DTB

Date: April 23, 2009
 Order No.: S-B-03.30/08i
 Supersedes: S-B-03.30/08h dated October 24, 2008
 Group: 03

SUBJECT: Model 164.156/172/186/871/886
Model 171.454/456
Model 203.052/054/056/087/092
Model 204.054/056/081/987
Model 209.356/372/456/472
Model 211.056/072/087/090/256/287
Model 216.371/386
Model 219.372
Model 221.171/186
Model 230.471
Model 251.156/165
Equipped with M272 or M273 Engine
Check Engine Light On / Fault Codes Current and/or Stored in ME-SFI Control
Module / Oil Leaking at Camshaft Adjustment Solenoid

Figure 1 – Damaged/worn S-B-03.30/08a

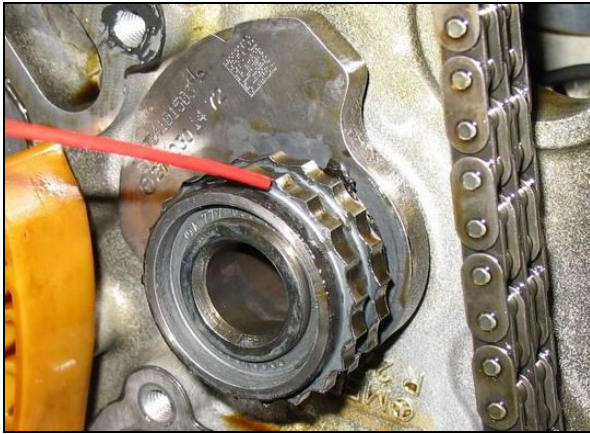
i **Note:** Refer to Figure 1 through 3 for examples of damaged / worn sprocket profile. Refer to Figure 4 for example of a new gear (for comparison).

- b) Only if worn (sprocket teeth profile damaged), replace the balance shaft on engine M272 or replace the guide (idler) gear of the chain drive on engine M273 as per WIS instructions AR03.20-P-1000* (* - applies to a specific model designation e.g. AR03.20-P-1000VA – model 171).

Figure 5

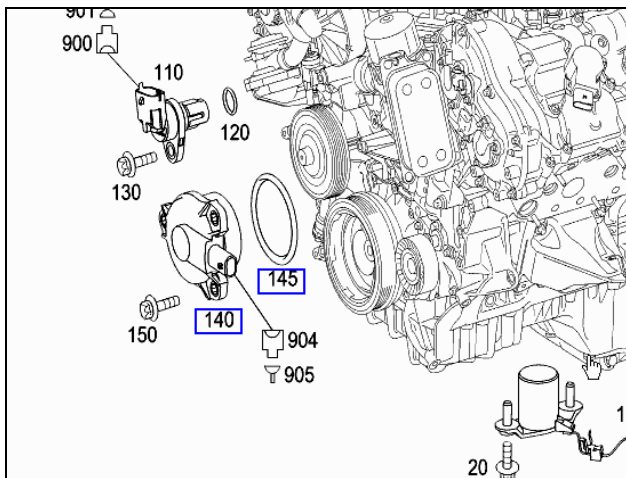
Fault Scenario 3: Camshaft adjustment solenoid is leaking oil, and no Fault Codes are current or stored in the ME Control Module. Determine the cause of the leak. The solenoid can be leaking from under the sealing ring or through the harness connector.

- a) If the leak appears to be between the solenoid and the cylinder head replace solenoid sealing ring (Figure 5, 145).
- b) If the leak is from the electrical connector, replace the solenoid (Figure 5, 140).

i Note: Provide description of where the leaking occurred and mark the replaced solenoid.
